COLORADO SPRINGS TEMPLE APPEAL

Planning Commission December 10, 2025

Staff Report by Case Planner: Tamara Baxter

File Number	Application Type	Decision Type
APPL-25-0008	Appeal of Administrative Decision	Quasi-Judicial

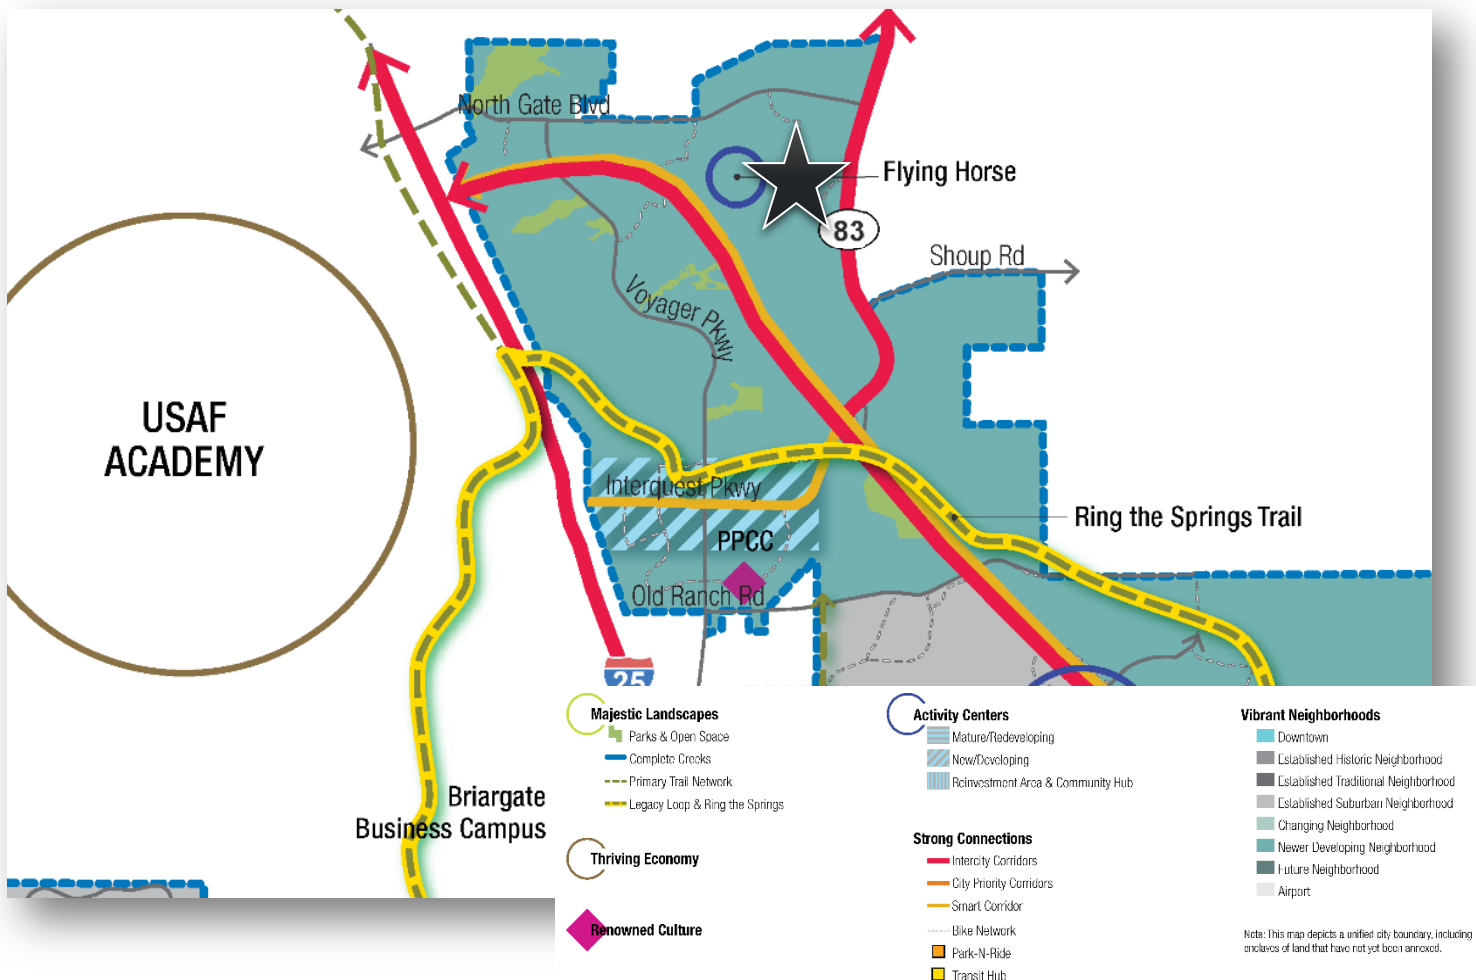
The Appellant has identified the administrative decision by City staff was erroneous, contrary to law, and contrary to the language expressed in the City Code, specifically to UDC Section 7.4.203(B)(2): Height Exemptions. The appellant has noted that “*steeple/spire exceeding height limits in a residential zones to be “designed or screened to minimize visibility.” The Applicant’s proposal does the opposite – its spire is deliberately designed to be visually dominant, continuously illuminated and unshielded.*” The Appellant also noted that staff approved the development plan despite objections and without imposing any visibility mitigation conditions.

As illustrated on Sheets 20-23 of the approved Development Plan, the building elevations for the Temple, the proposed building height of the building is 39 feet from finished grade. The steeple/spire height on the plan set illustrates approximately an additional 101 feet from the height of the proposed structure. In accordance with the height exceptions outlined in the UDC (see excerpt below), the height exception is based off the calculation of the maximum building heights, which in the MX-N (Mixed-Use Neighborhood Scale) is 45 feet. Thus, based on how building height is measured, the height of the steeple/spire above the maximum building height is calculated to be approximately 95 feet, not 140.5 feet.

- The elevation plan shows that total height of the building and steeple/spire as 140 feet from finished grade.
- The maximum building height in the MX-N zone is 45 feet
- The height of the steeple/spire, above the maximum building height, is 95 feet.

In accordance with the exemption to height requirements, the height of the steeple/spire cannot exceed 5 percent of the footprint of the primary structure. The proposed temple has a building footprint of approximately 33,374.57 square feet. Per UDC, the steeple/spire could extend up to 1,668 feet, based on the 5% footprint rule, though this is not a practical design scenario. The application proposed a steeple/spire of 95 feet. This is significantly less than what is allowed by the UDC.

With respect to screening of the steeple/spire per UDC Section 7.4.203.B.2, this section of the UDC reads that a building feature, such as the steeple/spire **“that extend beyond the maximum building height pursuant to Table 7.4.2-F shall be designed or screened to minimize visibility...”** As noted above, per Table 7.4.2-F, the exemption for the steeple/spire would allow for a 1,668-foot-tall feature but the proposed steeple/spire feature is 95 feet from the maximum building height. The steeple/spire has been designed with a stepped back profile to reduce its visual prominence as it rises. In addition, the on-site landscaping will eventually mature and provide additional screening of this feature and site lighting. A photometric plan was required with the development plan. Site and building lights have been designed to confine all light to the site and prevent light trespass from the property line (Sheets 29 – 35 of the Development Plan). The building lighting, specifically the light fixtures lighting the steeple/spire, have been shielded so that the light source is fully shielded to prevent visibility of the light beam from adjacent properties. The proposed lighting for this project is intended
